Author's response to

Associate Editor decision: Publish subject to technical corrections
by Jessie Creamean

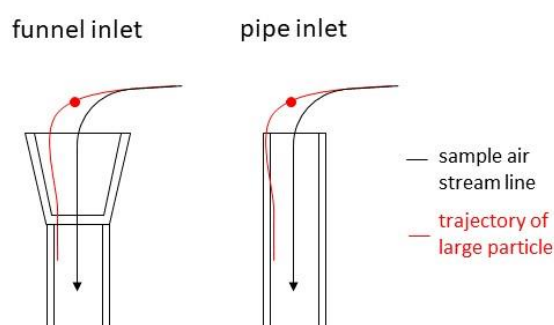
- Lines 324-325: Why is the sampling efficiency necessarily increased through the funnel geometry? Couldn't the geometry also increase losses (e.g., through impaction)?

Compared to a simple pipe inlet, the funnel geometry enables more larger particles with higher inertia to be sampled as illustrated in the following sketch:

→ Larger particle would impact into pipe wall due to inertia without the funnel

The only possible scenario in which particle impaction would be increased is when the particle's initial flow direction is from below. In this case, the change in flight direction of 180° would most likely also lead to a loss of large particles that cannot follow the streamline of the sample air due to inertia with a simple pipe inlet.
